# Access Compliance Report

## Public Rights-of-Way

### (Pedestrian Signals)

Intersection ID: N/A	Main Street:	Cross Street: N/A	Location: N/A
ADA ID: 1DD421B66A46	Signal Type: One Push Button-APS	Overall Compliance: No	Severity Score: BTN 1: N/A BTN 2: N/A No BTN: N/A
Codes/Mitigation Info/Possible Solution		Field Measurements/Component Compliance

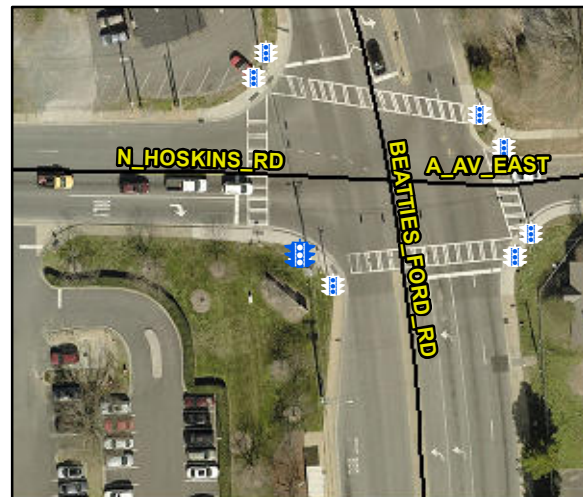
Compliance	Description	Data	Compliance	Description	Data
	Button Count	Button1	Yes	Distant to Additional Button (in)	408.0
	Additional Button Present?	Yes		Additional Button ID	1D00DA3A0F8A
N/A	Signal Buttons Required?	N/A	N/A	Additional Ped Posts Required	N/A
	How Many Ped Street Xings?	1		Located In An Island/Median?	No
N/A	B 1 Sign Present?	Yes	N/A	B 2 Sign Present?	N/A
Yes	B 1 Sign Purpose?	Yes	N/A	B 2 Sign Purpose?	N/A
Yes	B 1 Sign Lettering & Contrast?	Yes	N/A	B 2 Sign Lettering & Contrast?	N/A
Yes	B 1 Parallel To XWalk?	Yes	N/A	B 2 Parallel To XWalk?	N/A
Yes	B 1 PAR to Button?	Yes	N/A	B 2 PAR to Button?	N/A
Yes	B 1 PAR to XWalk?	Yes	N/A	B 2 PAR to XWalk?	N/A
Yes	B 1 Clear Floor Space?	Yes	N/A	B 2 Clear Floor Space?	N/A
N/A	B 1 FWD Approach?	No	N/A	B 2 FWD Approach?	N/A
N/A	B 1 FWD Approach Constrained?	No	N/A	B 2 FWD Approach Constrained?	N/A
N/A	B 1 FWD Approach Reach (in)	N/A	N/A	B 2 FWD Approach Reach (in)	N/A

N/A	B 1 FWD Approach Width (in)	N/A	N/A	B 2 FWD Approach Width (in)	N/A
N/A	B 1 FWD Approach Obstruction?	Yes	N/A	B 2 FWD Approach Obstruction?	N/A
N/A	B 1 FWD Approach Obstruction Dist (in)	6.0	N/A	B 2 FWD Approach ObstructionDist (in)	N/A
N/A	B 1 PARA Approach?	Yes	N/A	B 2 PARA Approach?	N/A
N/A	B 1 PARA Approach Constrained?	No	N/A	B 2 PARA Approach Constrained?	N/A
Yes	B 1 PARA Approach Reach (in)	10.0	N/A	B 2 PARA Approach Reach (in)	N/A
N/A	B 1 PARA Approach Width (in)	60.0	N/A	B 2 PARA Approach Width (in)	N/A
N/A	B 1 PARA Approach Obstruction?	Yes	N/A	B 2 PARA Approach Obstruction?	N/A
N/A	B 1 PARA Approach Obstruction Dist (in)	6.0	N/A	B 2 PARA Approach ObstructionDist (in)	N/A
Yes	B 1 Clear Floor Space Slope (%)	0.8	N/A	B 2 Clear Floor Space Slope (%)	N/A
Yes	B 1 Clear Floor Space XSlope (%)	0.5	N/A	B 2 Clear Floor Space XSlope (%)	N/A
N/A	B 1 PAR Slope (%)	1.2	N/A	B 2 PAR Slope (%)	N/A
Yes	B 1 Height (in)	48.0	N/A	B 2 Height (in)	N/A

Yes B 1 Clear Xing Direction?	ClearlyMarked	N/A B 2 Clear Xing Direction?	N/A
B 1 Crossing Direction	To N	B 2 Crossing Direction	N/A
Yes B 1 DistanceTo XWalk (in)	0.0	N/A B 2 DistanceTo XWalk (in)	N/A
No B 1 DistanceTo Curb (in)	76.0	N/A B 2 DistanceTo Curb (in)	N/A
Yes B 1 Diameter (in)	2.0	N/A B 2 Diameter (in)	N/A

Possible Solutions: Replace Signal Push Button With APS Button on New Post. Remove & Relocate Sign.
